## DOCUMENT CHANGE REQUEST

DCR number 118

Title: Capacitors, Fixed, Surface Mount,D.C. Self Healing, Non Inductive, Polyphenylene Sulphide

Number: 3006/023

**FIGURE 3 - FUNCTIONAL DIAGRAM**

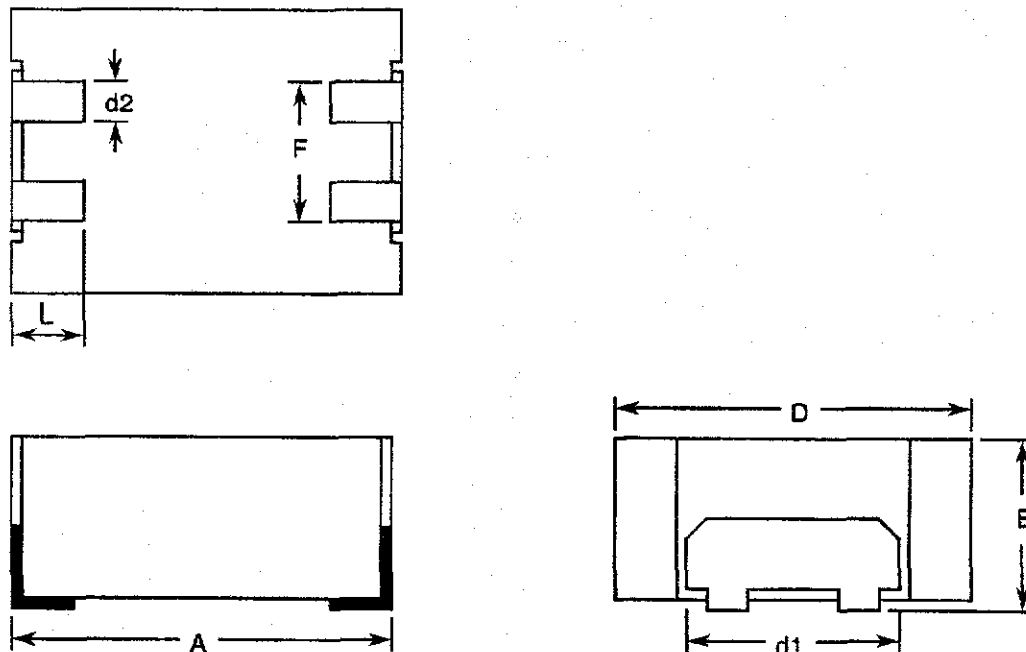
Figure 3: Polarity symbol deletion.  
Note deletion  
Para 4.5.1 and 4.5.1, delete reference to polarity

These capacitors do not need any voltage polarity symbol and never bore it with their marking. This note has been added by mistake in this specification by copying the spec 3006/024 which was created at the same time

Figure 3 : Polarity symbol deletion.  
Note deletion.

These capacitors do not need any voltage polarity symbol and never bore it with their marking.  
This note has been added by mistake in this specification by copying the spec 3006-024, which was created at the same time.

1. These capacitors are not polarised, however, marking includes the voltage polarity symbol indicated above, which should be respected in use.
